WESTINGHOUSE LONG TERM ICE
CONDENSER CONTAINMENT CODE -
LOTIC - 3 CODE

SUBJECT: EVALUATION OF PROPOSED SUPPLEMENT TO WCAP-8354 (LOTIC-3)

TOPICAL REPORT EVALUATION

Report No.: WCAP-8354 (Proprietary) and WCAP-8355 (Non-Proprietary)
Report Date: April 1976
Report Title: Long-Term Ice Condenser Containment Code - LOTIC Code
Originating Organization: Westinghouse Nuclear Systems
Reviewed By: Analysis Branch, Office of Nuclear Reactor Regulation

Figure 1 - Ice Condenser Exit Temperature vs. Time for Most Severe Small Break at 100% Power in a Typical Ice Condenser Plant.

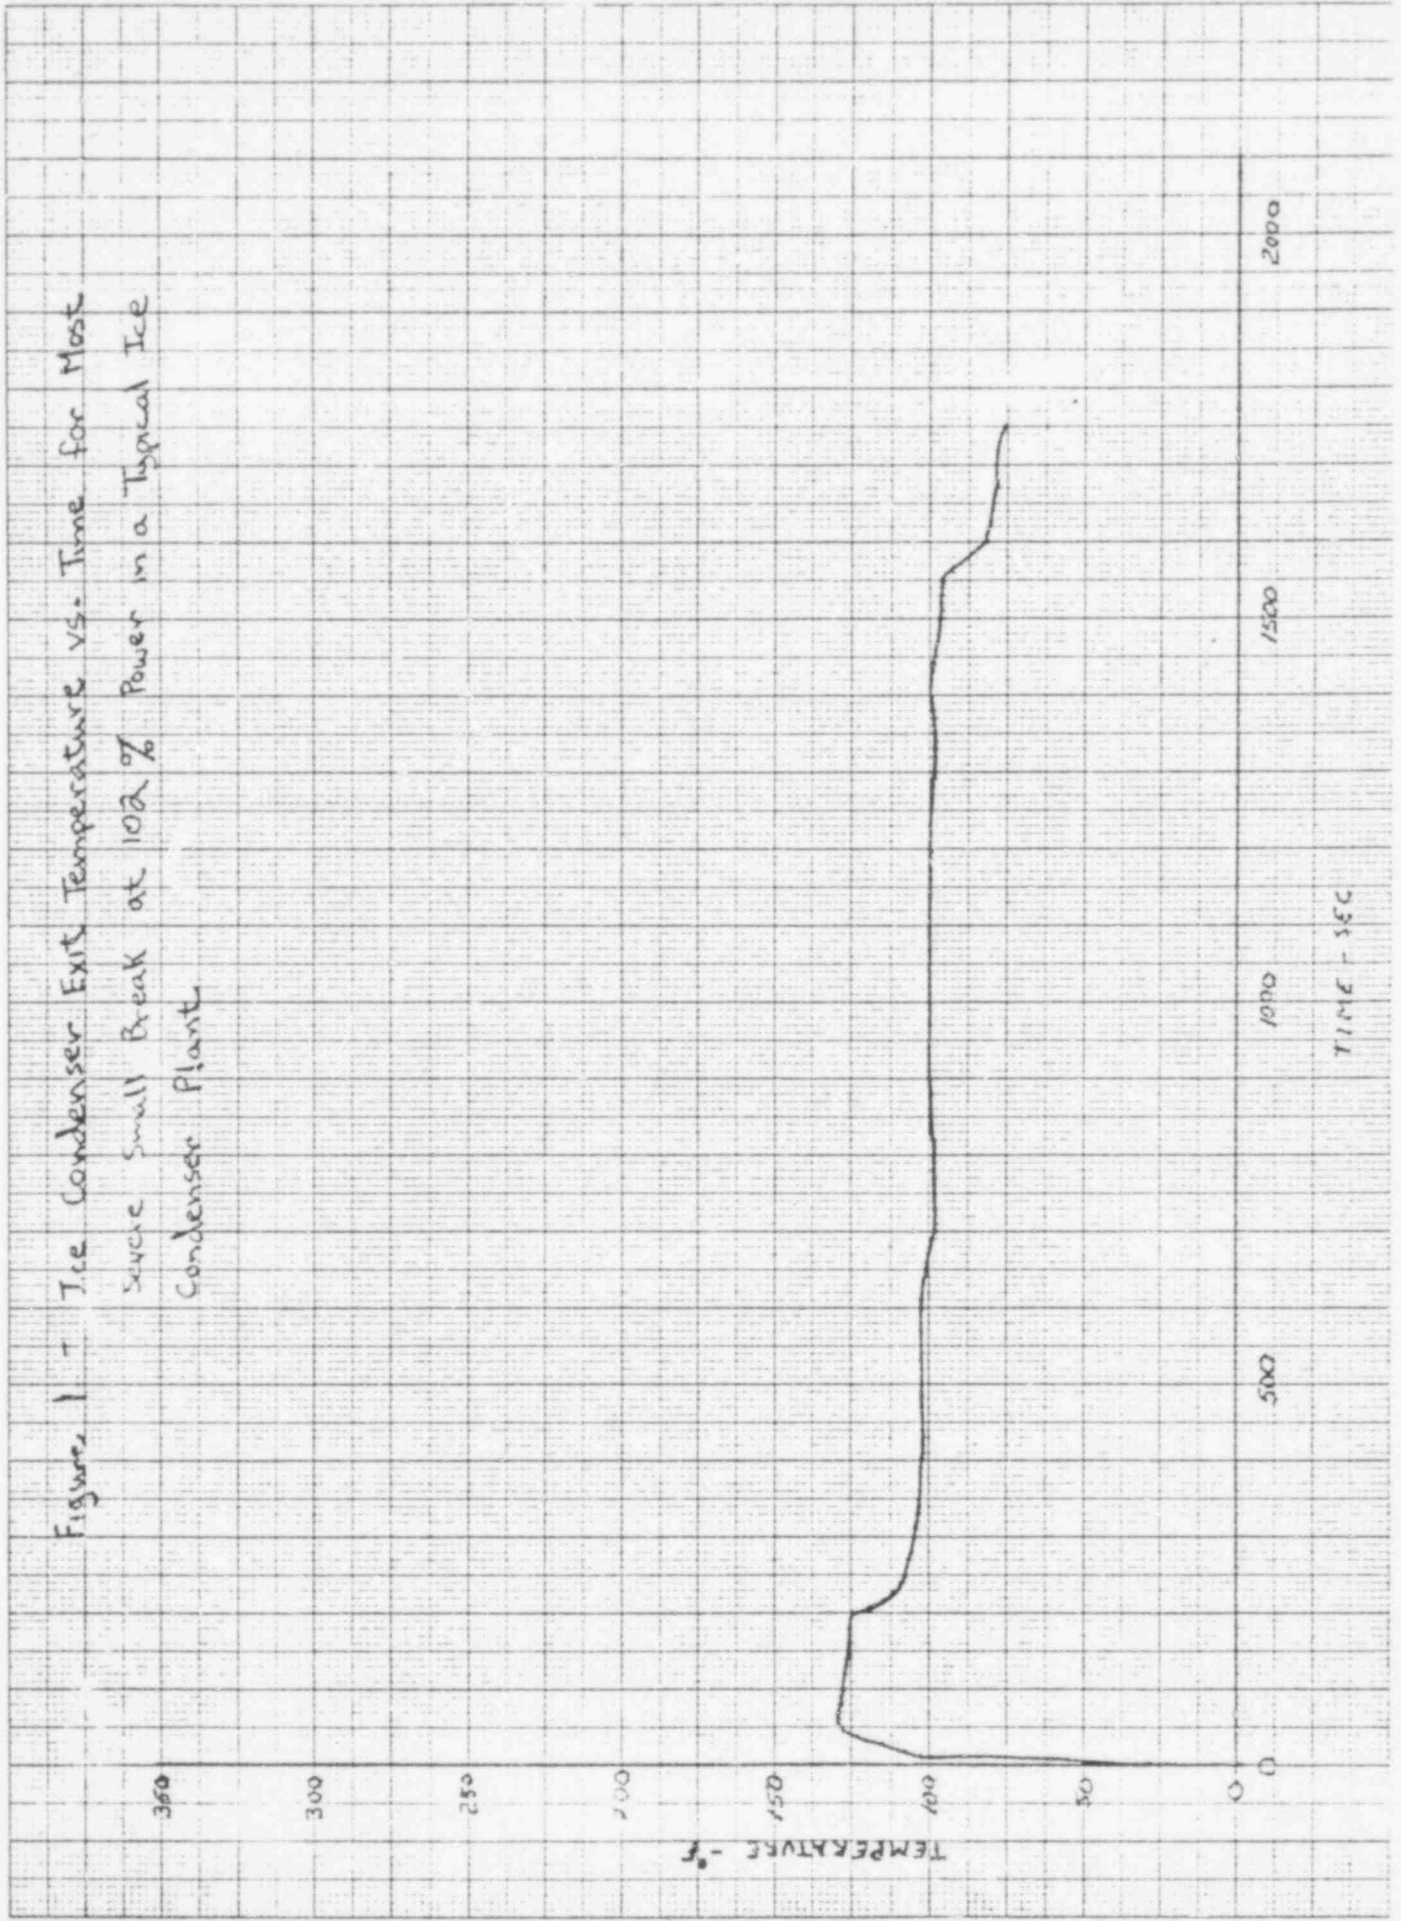
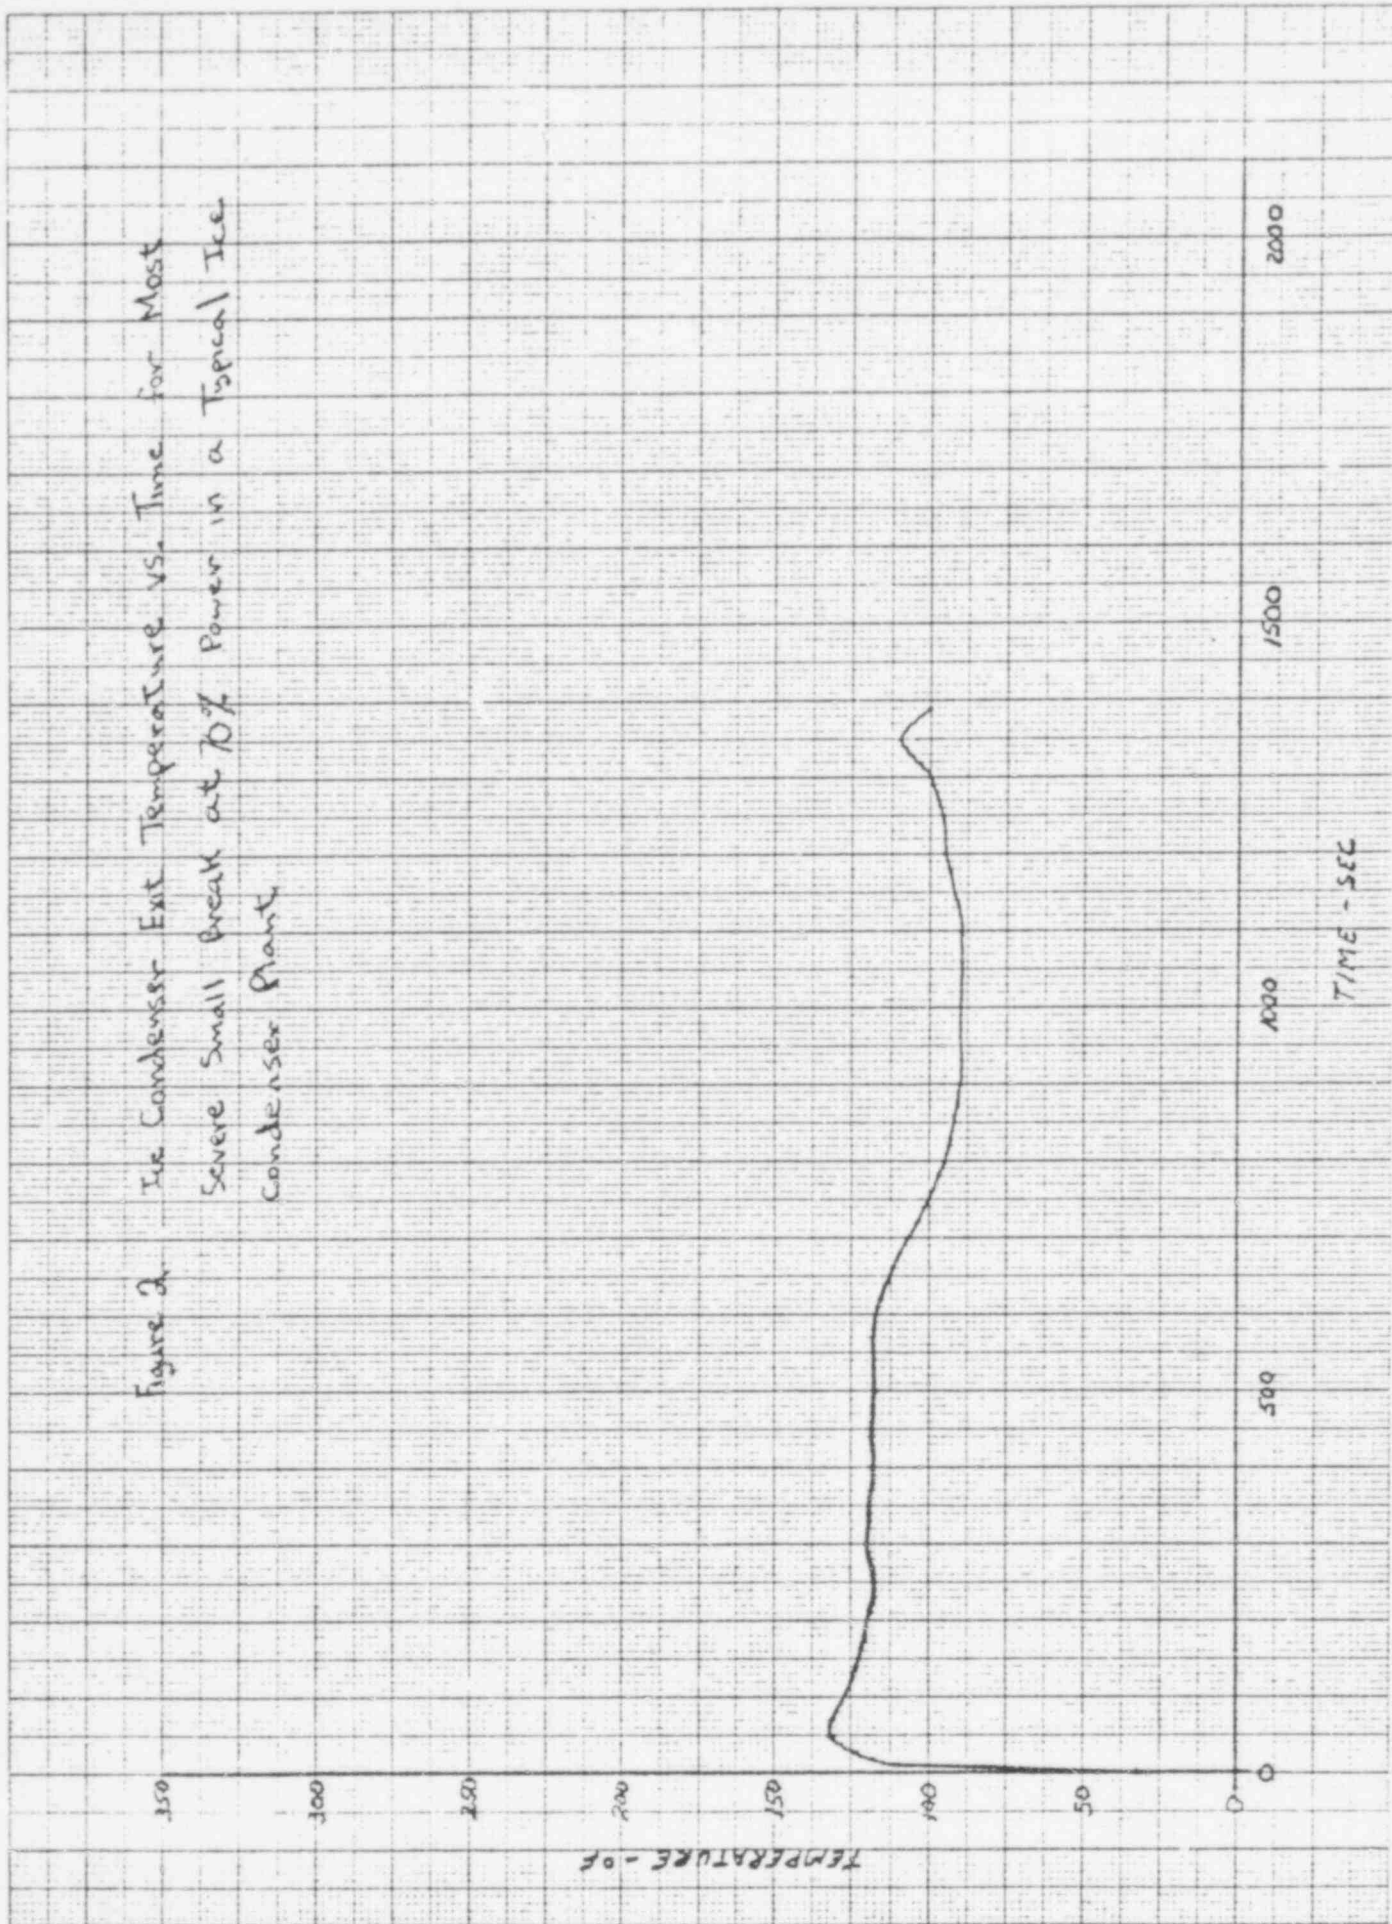
Provide and justify the assumption made for heat transfer to the ice baskets. Discuss the conservatism of these assumptions for containment analysis. Provide and justify the values assumed for the ice condenser air and water exit temperatures for the steamline break during the blowdown and post-blowdown periods.

The steam and air exit temperatures from the ice bed help set the containment pressure during the transient. The method LOTIC-3 uses to calculate ice condenser heat transfer (exit temperatures) is basically the same as that used by TMD (WCAP-8077, with the modifications noted in WCAP-8282). The eljac used is [^(a,b,c)], the same eljac as used by TMD. Since the limiting accidents are superheated, the lower compartment temperature transients are relatively insensitive to changes in containment pressure and thus to eljac. Figures 1 to 3 give ice condenser exit temperatures for three of the most severe small break accidents. (See Questions 7 and 12)
